# Access Compliance Report

## Public Rights-of-Way

### (Curb Ramps)

Intersection ID: 12797	Main Street: N_MYERS_ST	Cross Street: E_6TH_ST	Location: S
ADA ID: 188B2C79DFFC	Ramp Type: PerpDiag	Initial Pass/Fail: Fail	Overall Compliance: No
Severity Score: 46.25			
Codes/Mitigation Info/Possible Solution		Field Measurements/Component Compliance

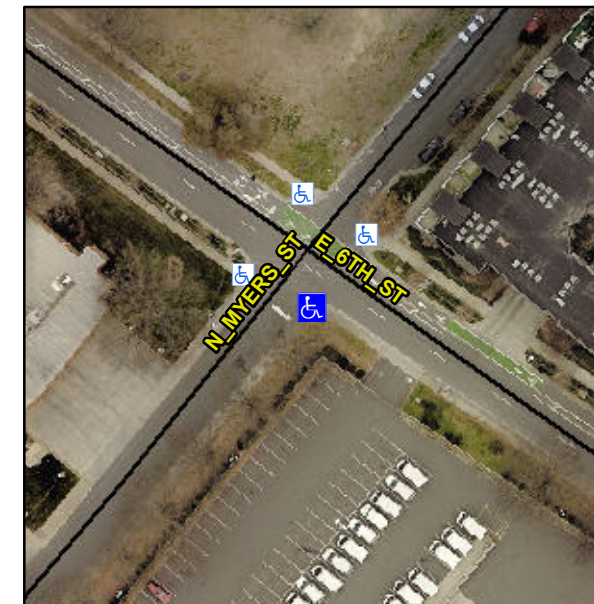
**Not Found, R304.5.1, R304.2.2, R304.5.3**

Compliance	Description	Data	Compliance	Description	Data
N/A	Ramp Length (in)	67.0	No	Ramp Slope (%)	9.7
No	Ramp Width (in)	38.0	No	Ramp XSlope (%)	7.3
N/A	Flare Type LT	N/A	N/A	Flare Type RT	N/A
N/A	Flare Slope LT (%)	N/A	N/A	Flare Slope RT (%)	N/A
N/A	Flare Traversable LT?	N/A	N/A	Flare Traversable RT?	N/A
N/A	Landing Length (in)	N/A	N/A	DWS Provided?	N/A
N/A	Landing Width (in)	N/A	N/A	DWS Contrast?	N/A
N/A	Landing Slope (%)	N/A	N/A	DWS Length (in)	N/A
N/A	Landing X Slope (%)	N/A	N/A	DWS Full Width?	N/A
N/A	Landing Curb? (Y/N)	N/A	N/A	DWS Offset (in)	N/A
N/A	Shared Landing?	N/A			
N/A	Gutter Ponding?	N/A	N/A	Gutter Slope (%)	N/A
N/A	Gutter Lip Ht (in)	N/A	N/A	Gutter X Slope (%)	N/A
N/A	Painted X Walk1?	No	N/A	Painted X Walk2?	No
	X Walk 1 Direction	To NE		X Walk 2 Direction	To NW
N/A	X Walk 1 Width (in)	N/A	N/A	X Walk 2 Width (in)	N/A
	X Walk 1 Slope (%)	0.5		X Walk 2 Slope (%)	7.0
	X Walk 1 X Slope (%)	4.2		X Walk 2 X Slope (%)	1.9

**Remove & Replace Curb Ramp With Two New Directional Ramps or Equivalent.**
